UNITED STATES PATENT AND TRADEMARK OFFICE

Office Action Summary	Application No. 10/751,700	Applicant(s) OSBORNE, CHRISTOPHER M.	
	Examiner Árpád Fábri Kovács	Art Unit 3671

DETAILED ACTION

2. Claims 1-22 are rejected under 35 U.S.C. 102(b) as being anticipated by Hill (5003757).

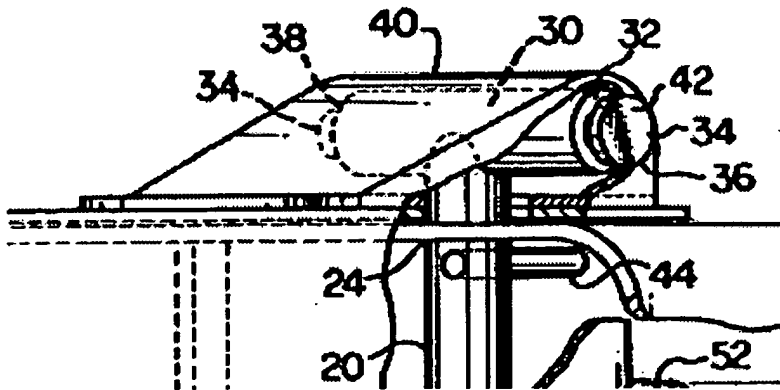
In re cl. 1, 9, 17, 2, 10:

A chute flap / deflector (14) open/closed positions & pivotally attached to the housing (descrip. ¶ 4);

A retaining flap / mounting bracket (40 & T swivel 20) moveably attached to the housing (descrip. ¶ 5-6, can be raised in position D), so the retaining flap/bracket's at least one portion can move generally vertical direction;

it is noted the retaining flap is independent of the flap, or not part or integral of the flap;

FIG. 4

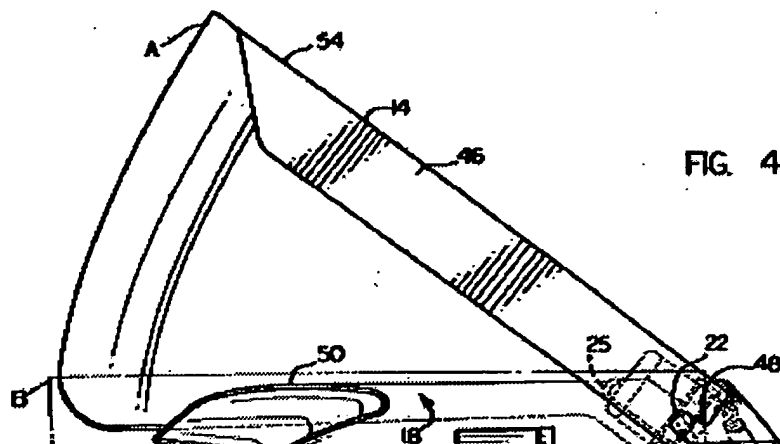
in re cl. 4, 12:

the chute flap comprises: a flange & wall portions as shown below:
